**Item Number: 15.2  
Title: 38 Storey Motel  
Including Ground Level  
Commercial Tenancies and  
Parking - PA2017/0442 - Lot  
566 (84) Mitchell Street,  
Darwin City**

Your reference: PA2017/0442

**Parcel Description:** Lot 566 (84) Mitchell Street, Darwin City

**Proposed Development:** 198 room motel, 23 x 3 bedroom multiple dwellings and ground level commercial tenancies in a 38 storey building including 4 above ground parking levels plus a plant and services basement level

GROUND FLOOR LANDSCAPE PLAN

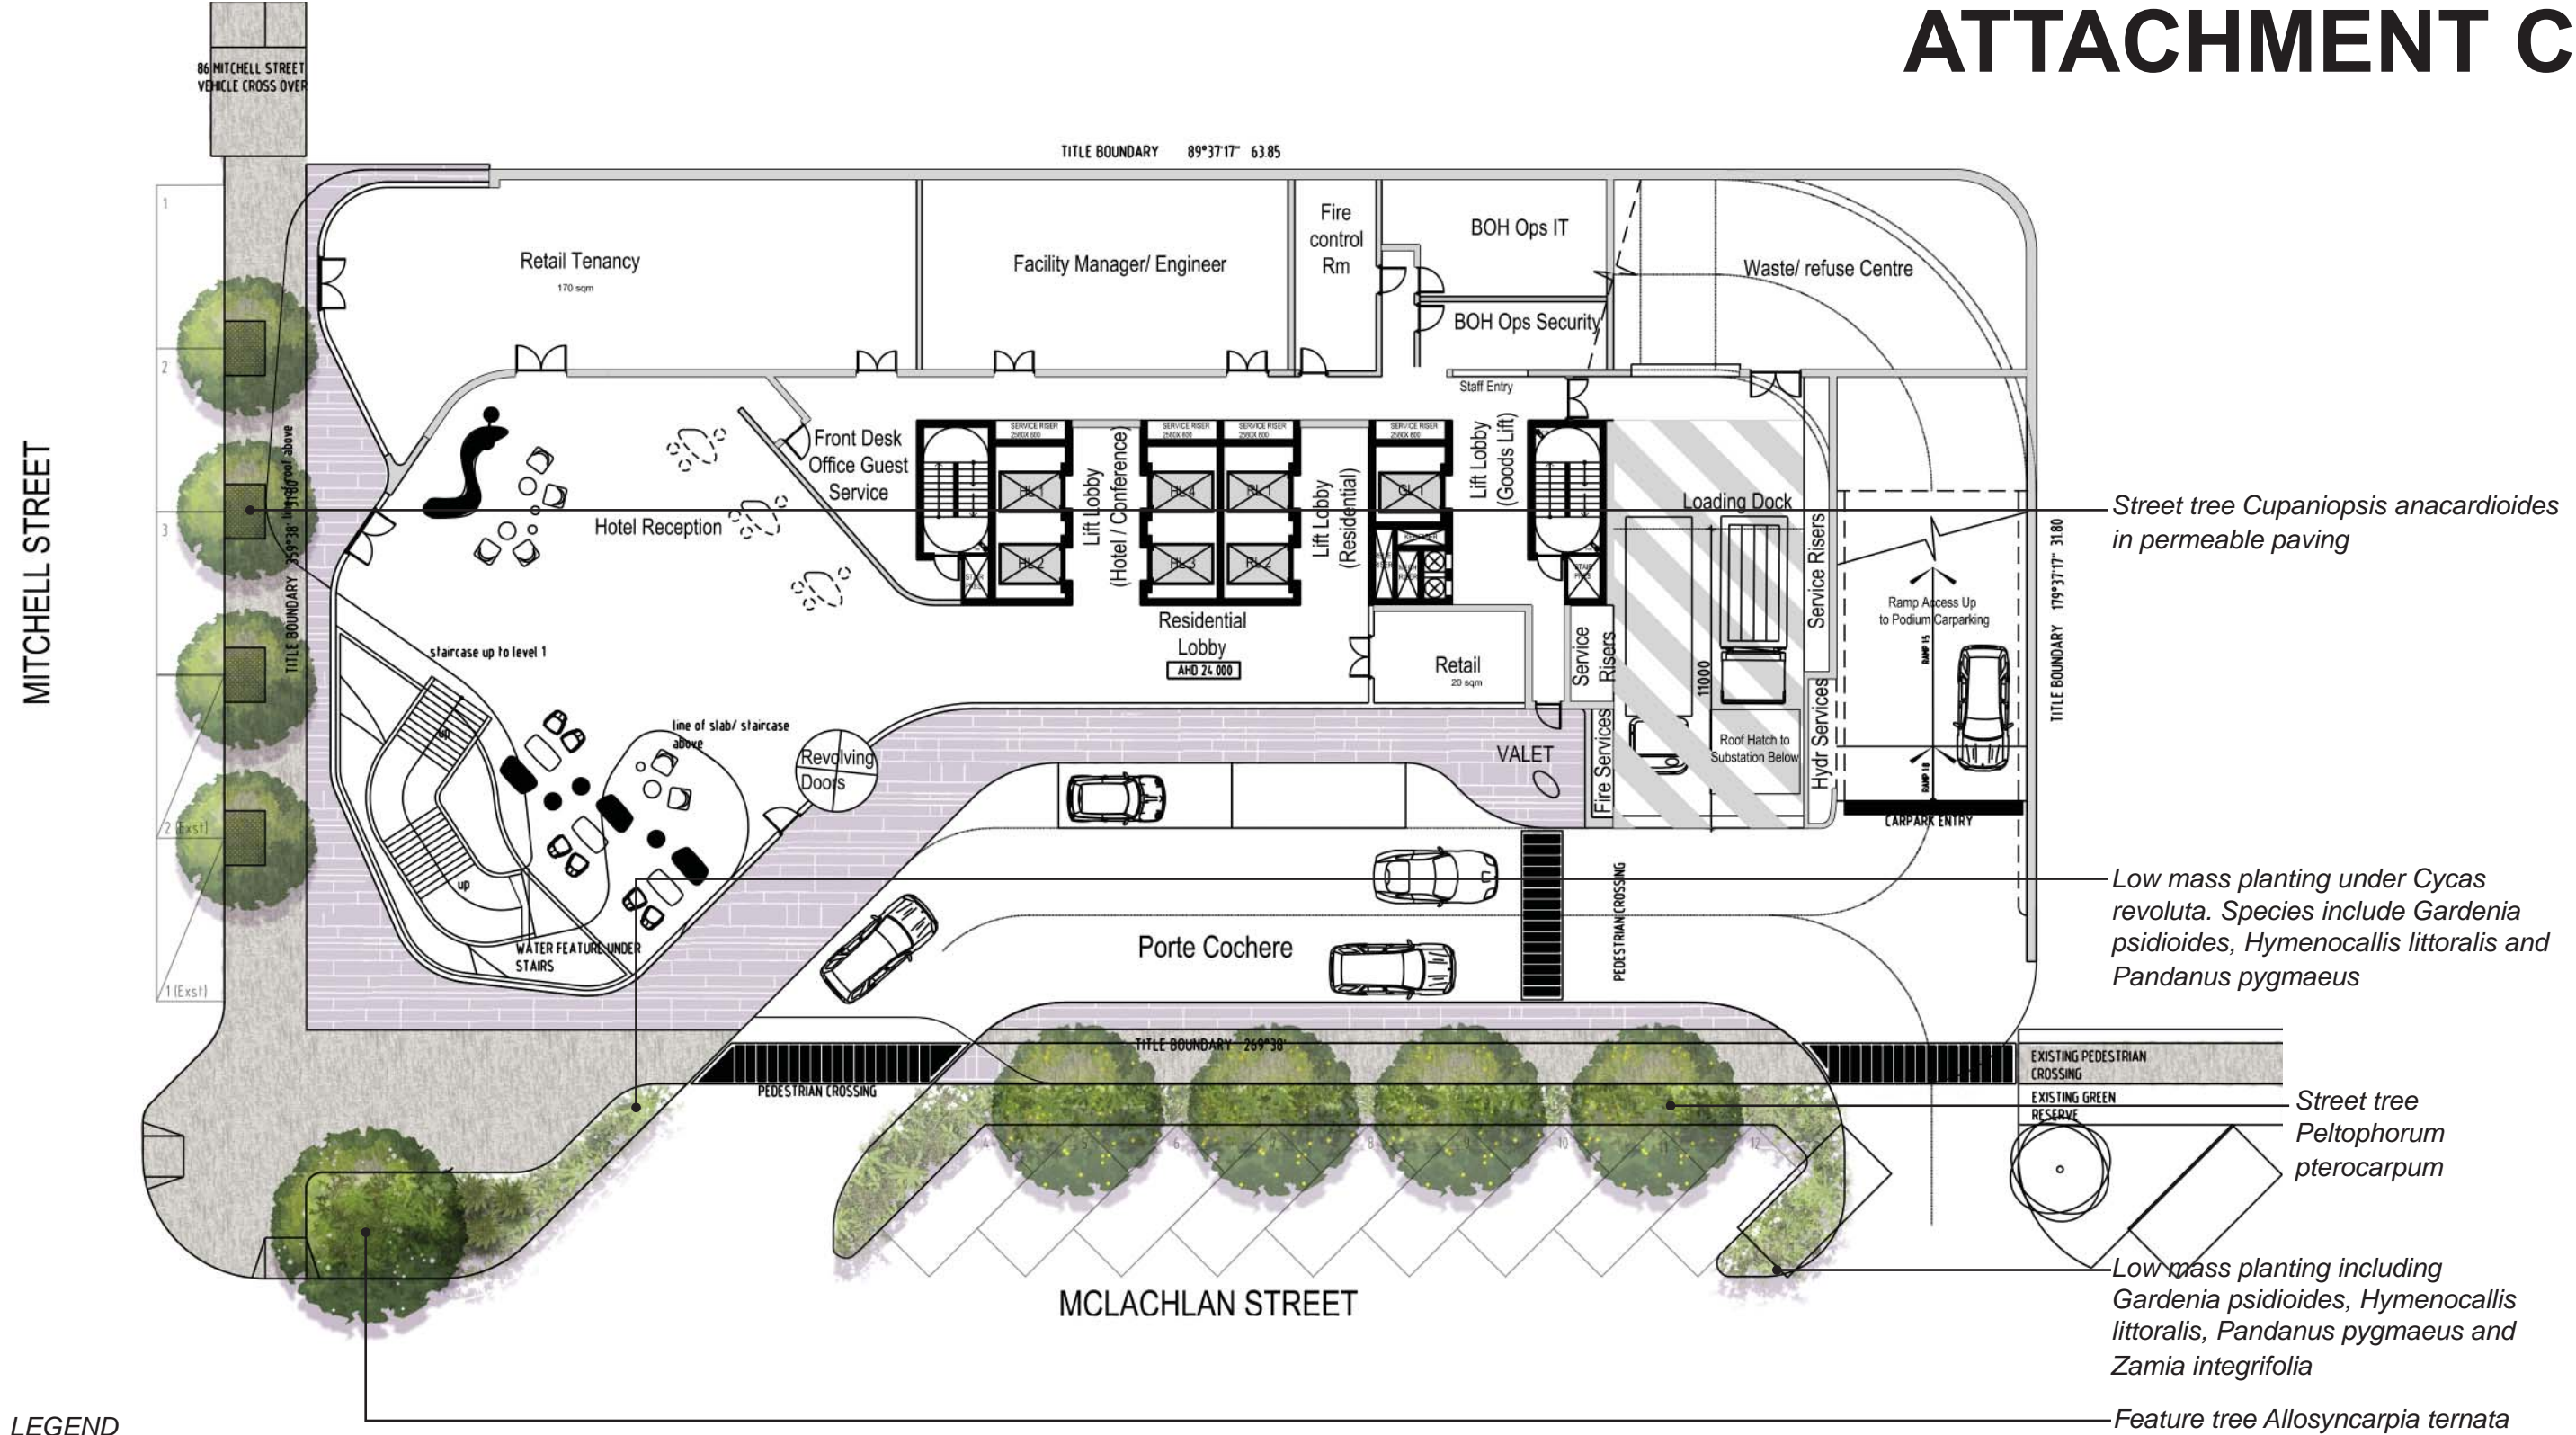
- b). City of Darwin acknowledges the provision of a landscaping plan as part of the application which includes landscaping within City of Darwin road reserve. Any landscaping within City of Darwin road reserve must be in accordance with City of Darwin requirements. The landscaping plan is considered generally acceptable, however, the following amendments are requested:

- Replace *Cupaniopsis anacardioides* with *Allosyncarpia ternata*

- along Mitchell Street.
  - Structural tree planting pits/trenches are required, that provide at least 10m<sup>2</sup> of growing media per tree.
- c). City of Darwin considers the 'Green Wall' to be crucial in the overall amenity and reducing the visual impact of the proposed development on the locality and requests that any amendment to this application that suggests the removal of this portion of landscaping be referred to the City of Darwin for further consideration. City of Darwin also requests that a general condition be placed on any Development Permit requiring that any landscaping be appropriately maintained with any diseased or dying plants promptly replaced.
